IMPERIAL COMMUNITY COLLEGE DISTRICT
IMPERIAL VALLEY COLLEGE
WATER AND WASTEWATER PLANT IMPROVEMENTS

ADDENDUM #03

THE FOLLOWING ITEMS ARE LISTED AS CORRECTIONS OR CLARIFICATIONS TO THE CONSTRUCTION DOCUMENTS.

SITE SURVEY AND DEMOLITION PLAN — SCALE: 1" = 10'-0" — A

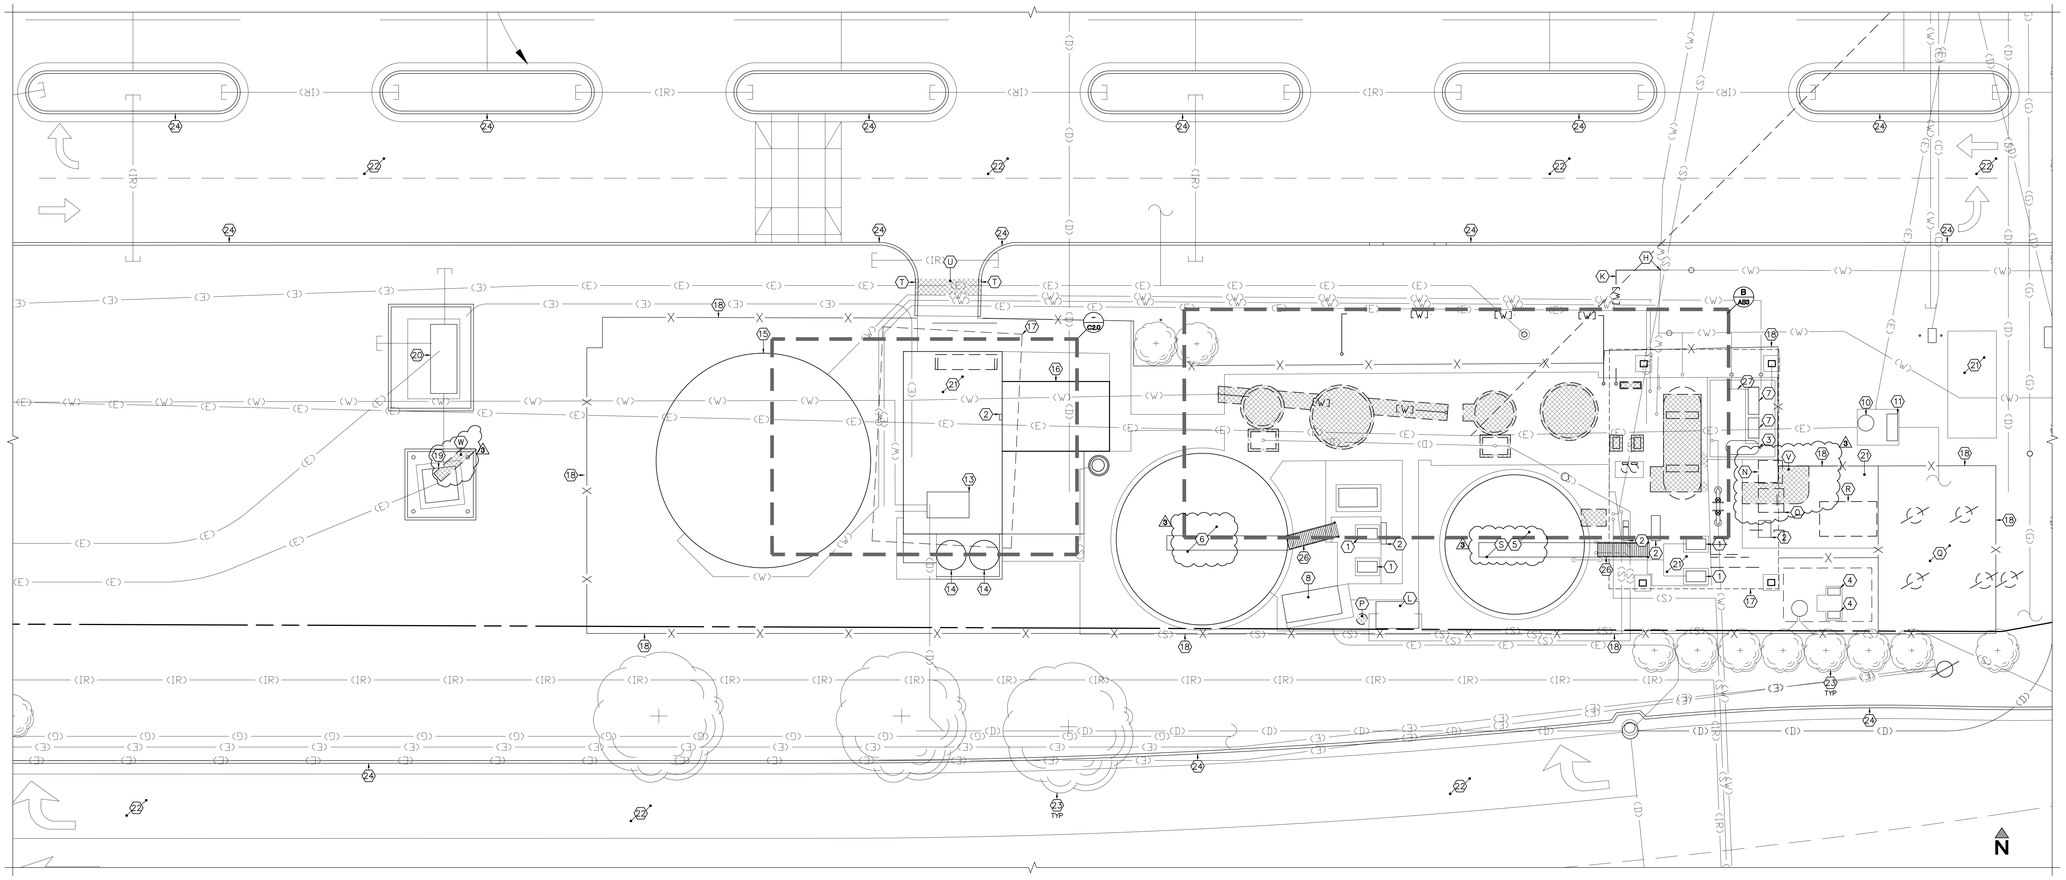
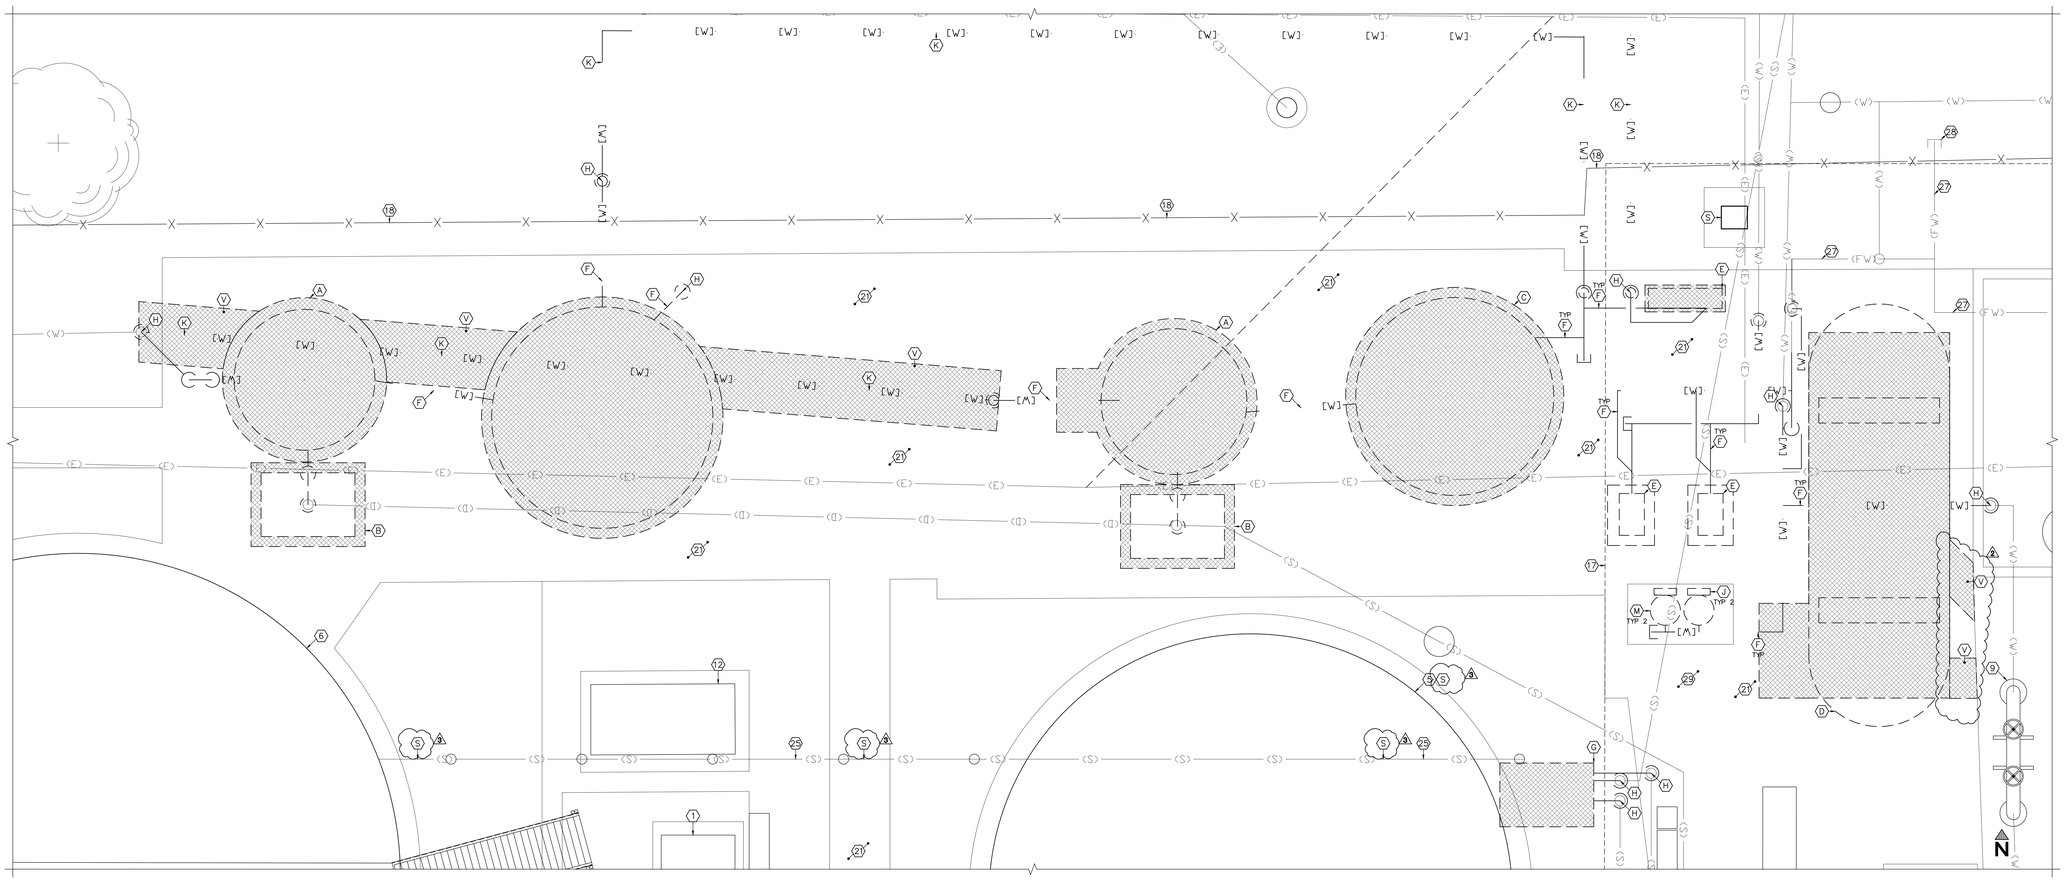
1. AS3 - SITE SURVEY AND DEMOLITION PLAN, DEMOLITION UTILITY PLAN
    a. Sheet AD-02_AS3 shall be replaced by Sheet AD-03_AS3 attached to this addendum. All changes to this sheet are clouded.

- (R) REMOVE EXISTING ELECTRICAL MAIN DISTRIBUTION PANEL
- (S) REMOVE COATING FROM WASTEWATER PLANT INTERIOR AND EXTERIOR SURFACE AND ASSOCIATED COMPONENTS PER SSPC–SP10 NACE 2 STANDARD

HARDSCAPE

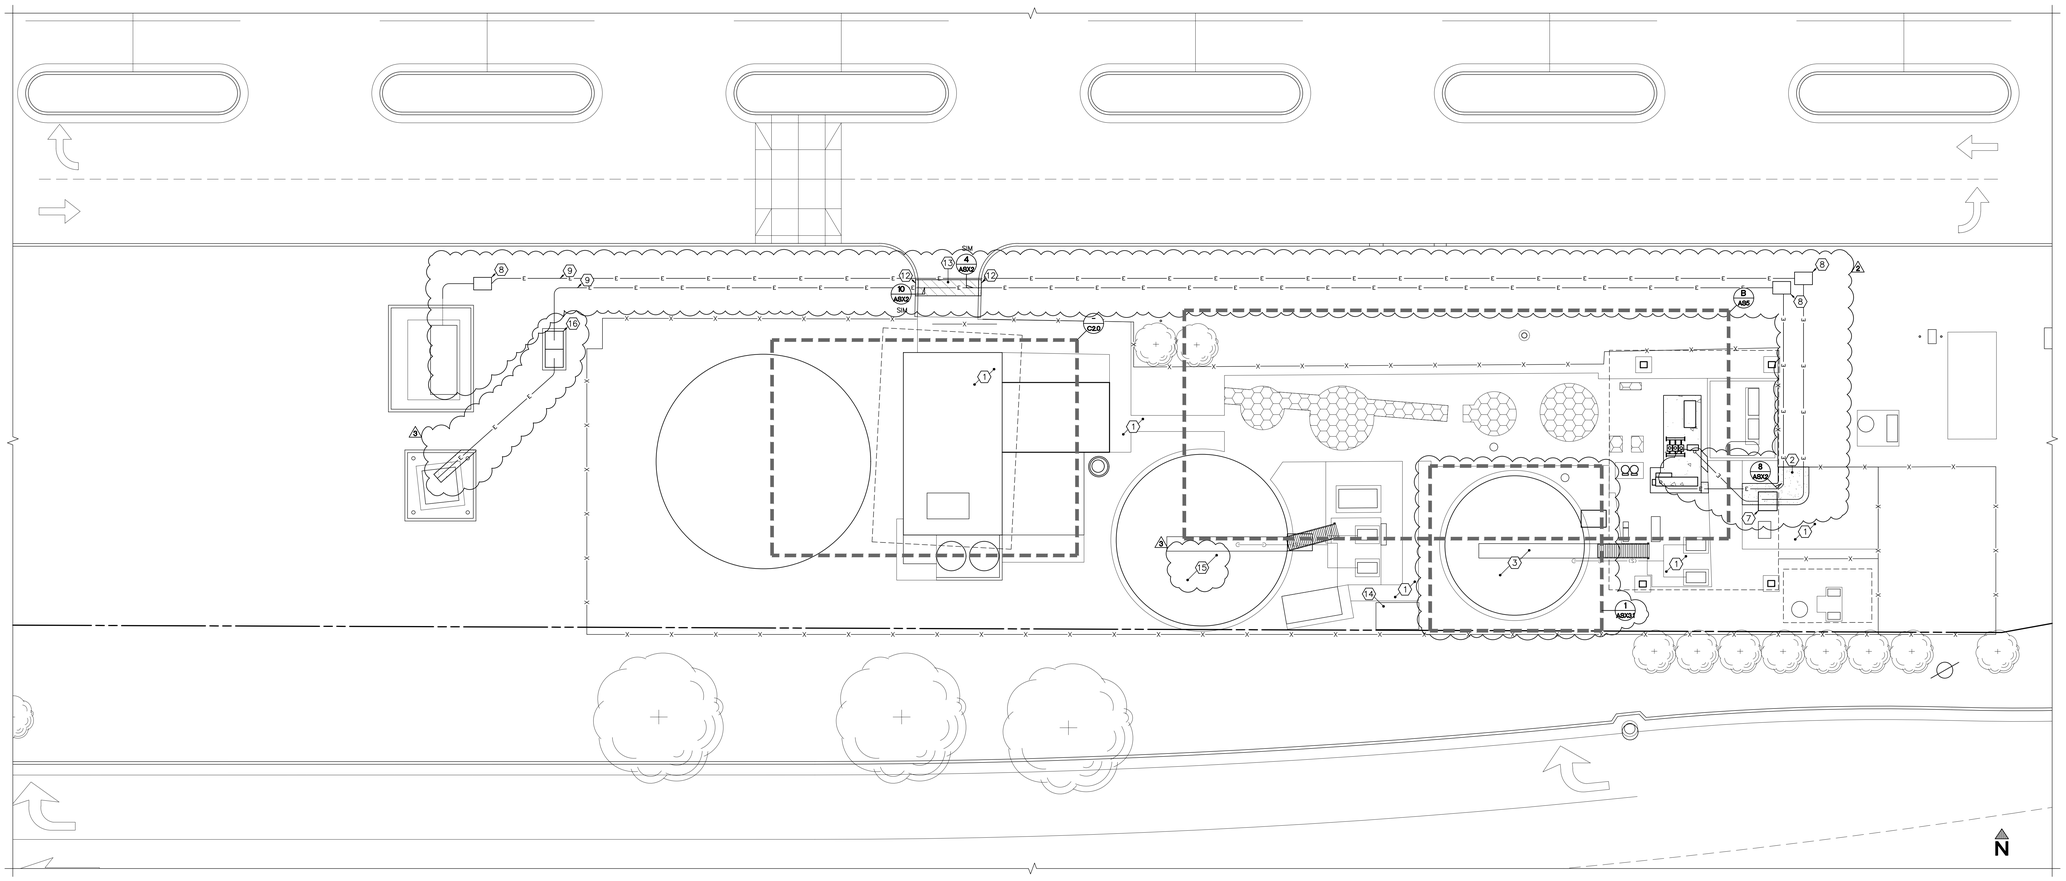
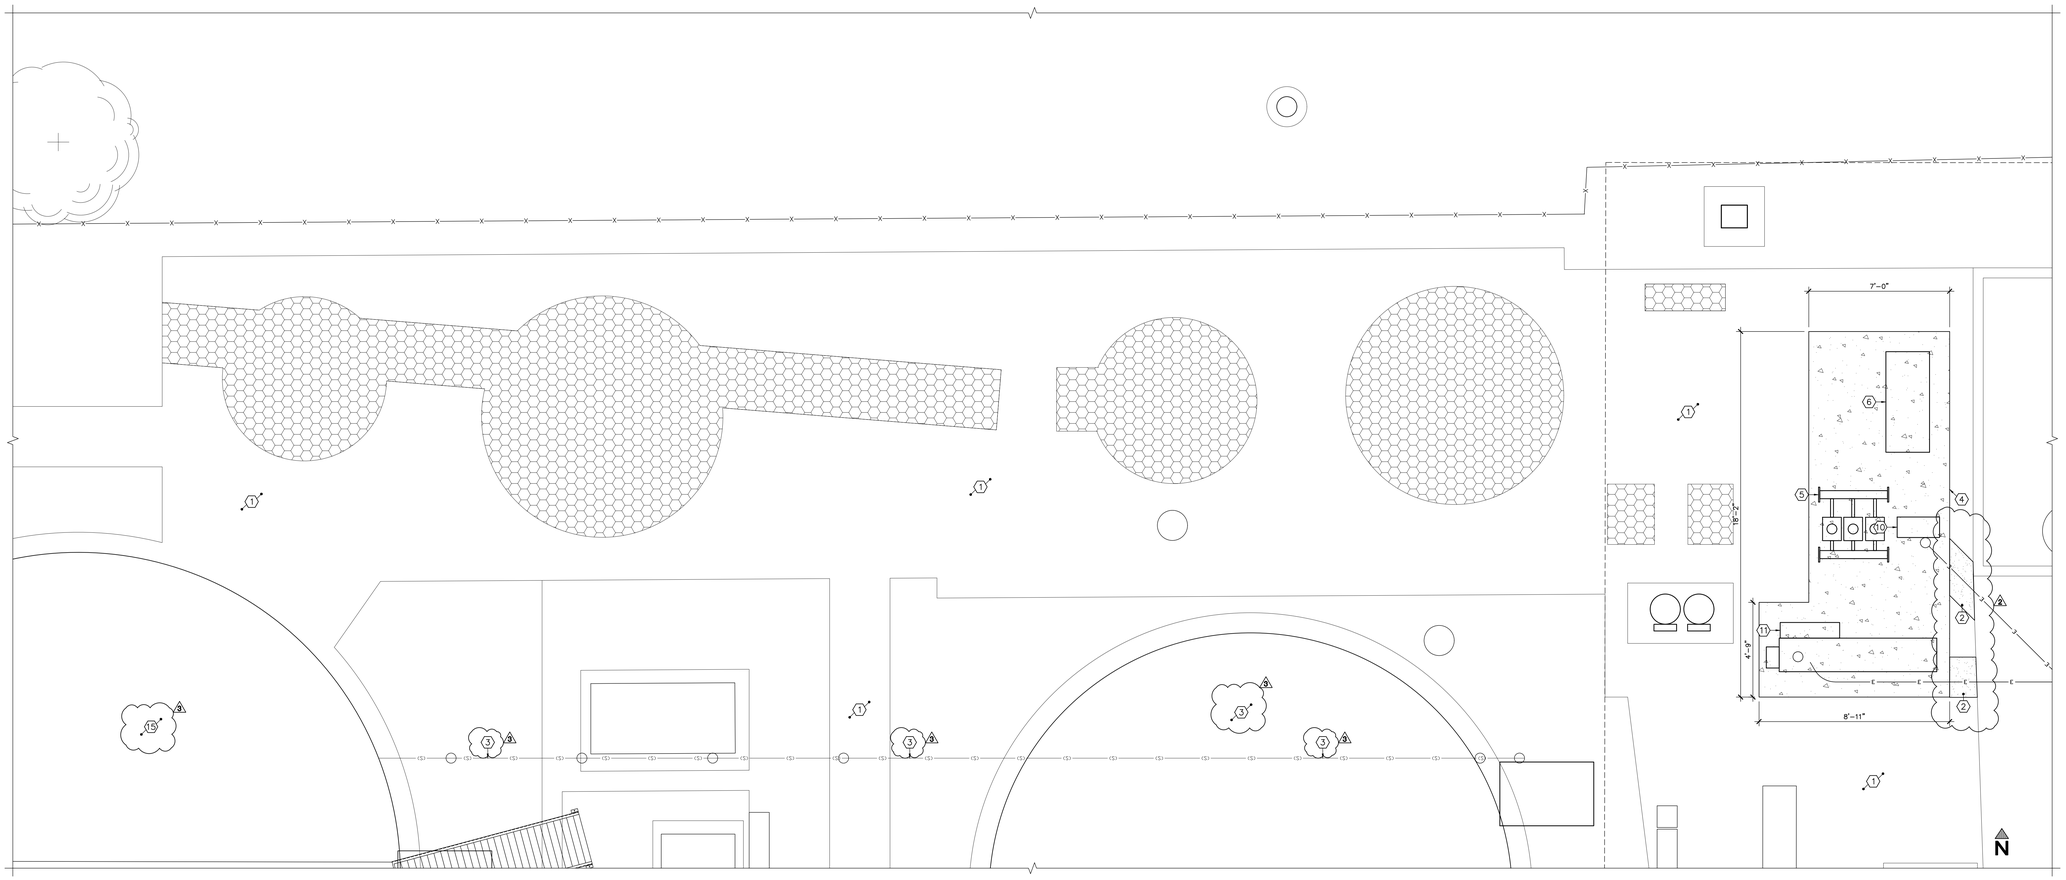
2. AS5 – HARDSCAPE
    a. Sheet AD-02_AS5 shall be replaced by Sheet AD-03_AS5 attached to this addendum. All changes to this sheet are clouded.

1. EXISTING CONCRETE WALK – PROTECT
2. 6" THICK CONCRETE WALK (1/A8X2)
3. PROVIDE SHERWIN WILLIAMS DURA-PLATE 6100 HIGH PERFORMANCE EPOXY W/ HIGH BUILD HARDENER B62VH8475. APPLY DRY FILM THICKNESS OF 275 MILS PER MANUF REQUIREMENTS TO 50K AND 100K GALLON PACKAGED WASTEWATER PLANT FOR INTERIOR AND EXTERIOR SURFACE AND ASSOCIATED COMPONENTS

50k GALLON WASTEWATER PLANT - ENLARGED PLAN | SCALE: NTS | 1

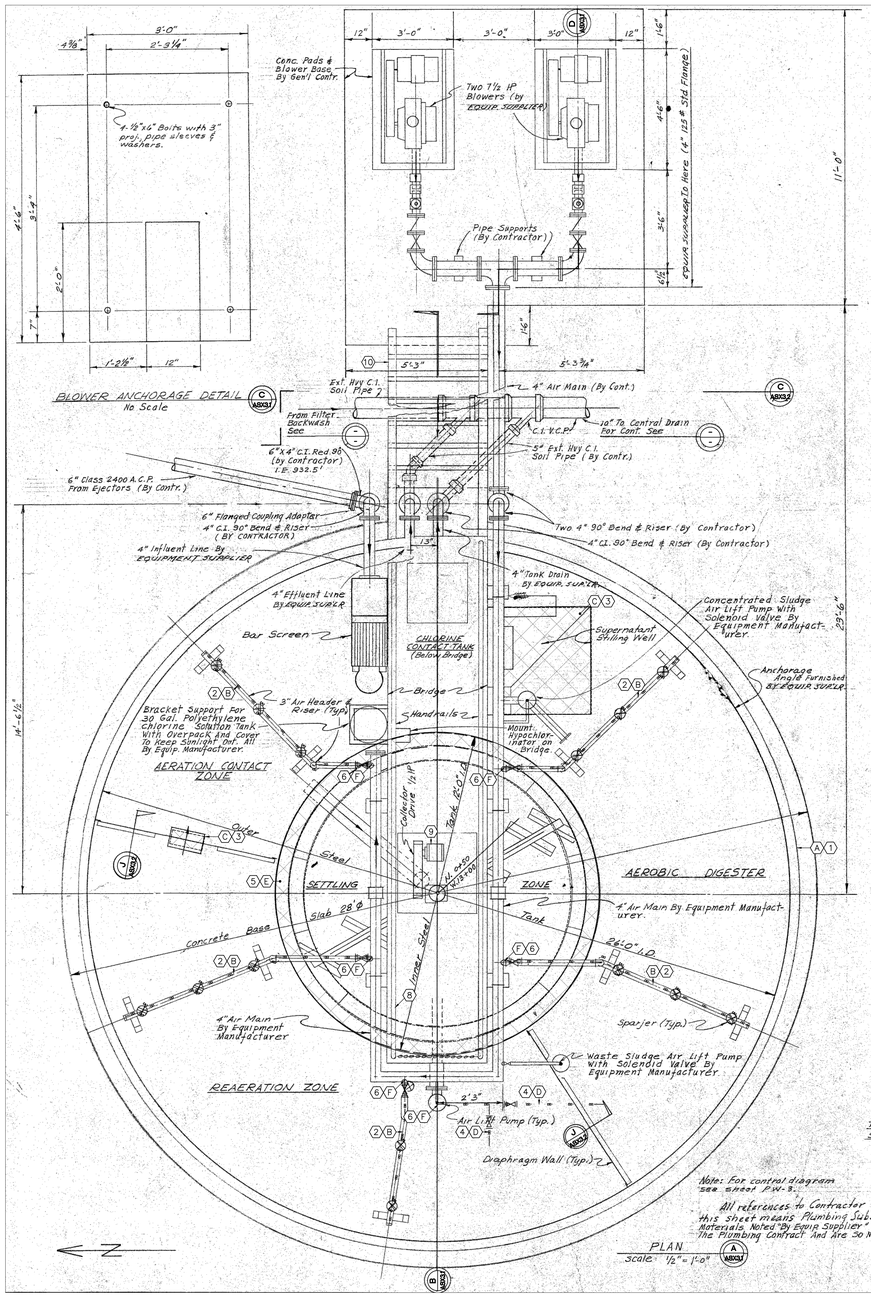
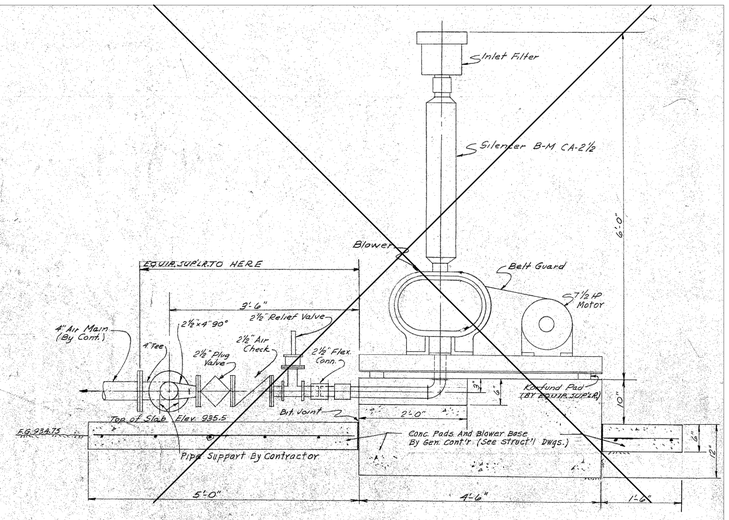
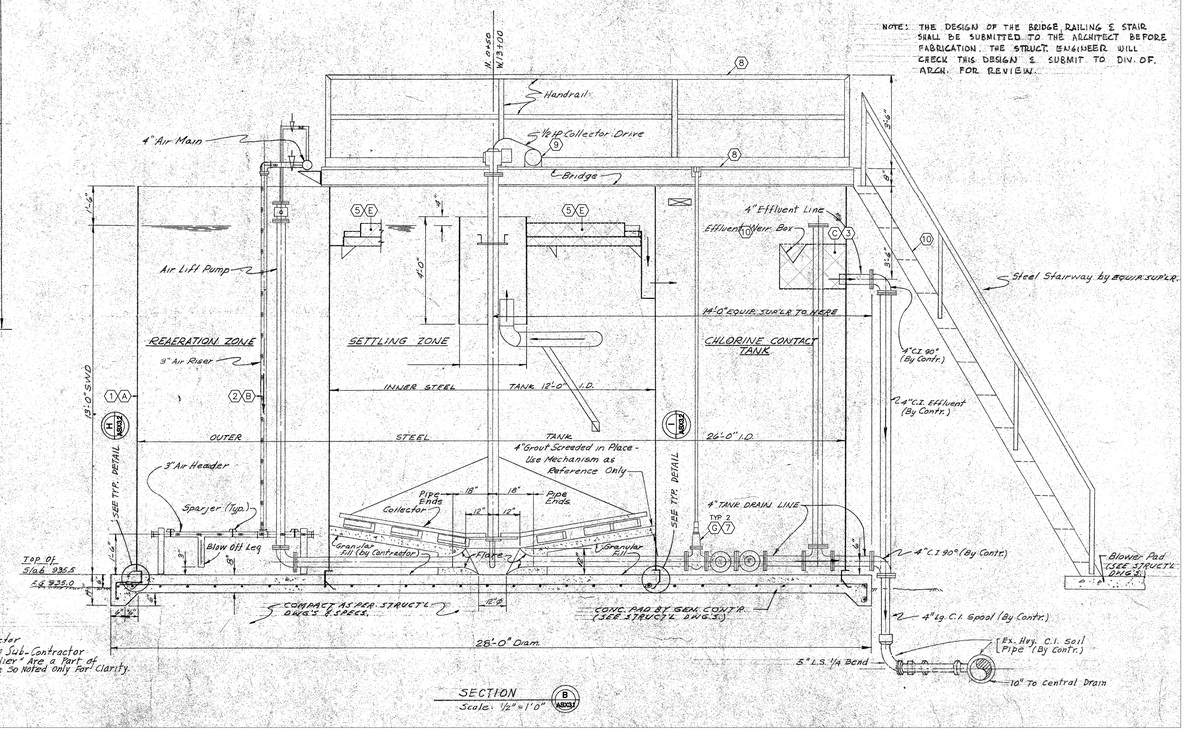
4. ASX3.1 – 50K GALLON WASTEWATER PLANT – ENLARGED PLAN
    a. Sheet ASX3.1 was omitted from Bid Set in error, Sheet ASX3.1 shall be included in Bid Set Drawings and is attached to this addendum.

1. PROVIDE SHERWIN WILLIAMS DURA-PLATE 6100 HIGH PERFORMANCE EPOXY W/ HIGH BUILD HARDENER B62VHB475. APPLY DRY FILM THICKNESS OF 275 MILS PER MANUF REQUIREMENTS TO 50K AND 100K GALLON PACKAGED WASTEWATER PLANT FOR INTERIOR AND EXTERIOR SURFACE AND ASSOCIATED COMPONENTS
2. PROVIDE CAST IRON PIPING, VALVE AND SPARJER. FIELD VERIFY SIZES
3. PROVIDE STEEL TRANSFER BOX. FIELD VERIFY SIZES
4. PROVIDE 3" PVC PIPING AND VALVE
5. PROVIDE STEEL PLATES / SEPARATOR
6. POINT OF CONNECTION
7. PROVIDE VALVE. FIELD VERIFY SIZE
8. EXISTING BRIDGE / HANDRAIL TO REMAIN – PROTECT
9. EXISTING PUMP TO REMAIN – PROTECT. PROVIDE SHEET METAL COVER.
10. EXISTING LADDER TO REMAIN – PROTECT.
